**PRODUCT NOTICE**  
Notice of Potential Product Concern

**Bulletin 1512 Medium Voltage Motor Control Center (MV MCC)  
Catalog Numbers 1512\*-6\*\*, 1526E-6\*\* and 1591\*-6\*\***

Reference: 2011-01-001

Date: January 2011

Photos showing possible locations of affected wires within panel. Affected wire may be concealed within a corrugated sleeve.

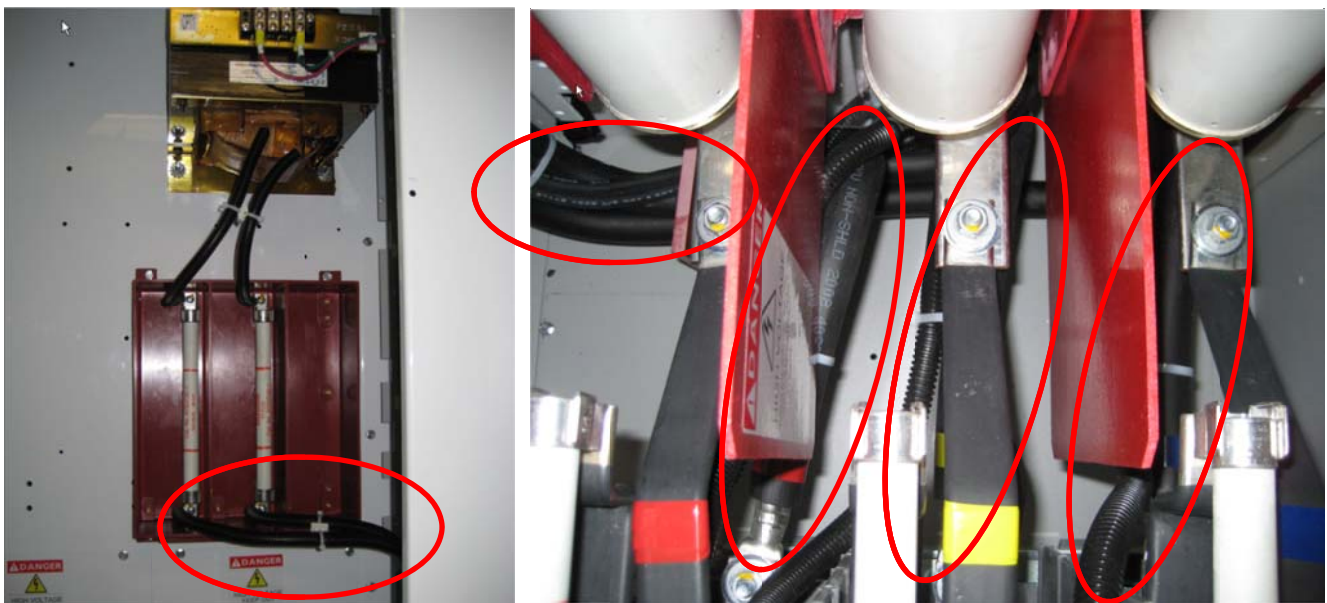
Within the Medium Voltage Motor Control Center panel, the wire connecting Potential Transformers (PT) or Control Power Transformers (CPT) may have a 600 volt insulation rating on the medium voltage primary or primary fuses. If not corrected, the 600 volt rated insulation may degrade over time leading to potential insulation failure. When the insulation fails, the wires within the controller may short circuit leading to a fuse opening, or the controller may shut off due to loss of control signals. Affected #8 AWG wires within the panel must be inspected for the proper 7500 volt insulation rating and replaced if incorrect.

Wire markings showing incorrect 600V insulation rating.

Wire markings showing correct 7500V insulation rating.

Potential Transformer (PT) and Control Power Transformer (CPT) wiring on the medium voltage primary and primary fuses must be inspected for proper insulation voltage rating. Check that these wires are marked for a 7500V insulation rating. If the wire is not rated at 7500V it must be replaced with 7500V #8 AWG wire with corrugated tubing at least 30 cm from each end. Only personnel who have been trained and understand the Medium Voltage Motor Control Center can work on this equipment. Appropriate PPE and applicable safety procedures must be followed at all times. Rockwell Automation will provide a retrofit kit with the replacement parts to correct the anomaly. The retrofit kit may be obtained by contacting Rockwell Automation Technical Support and referencing this Product Notice. Rockwell Automation does not recommend the use of non-Rockwell Automation provided replacement parts.
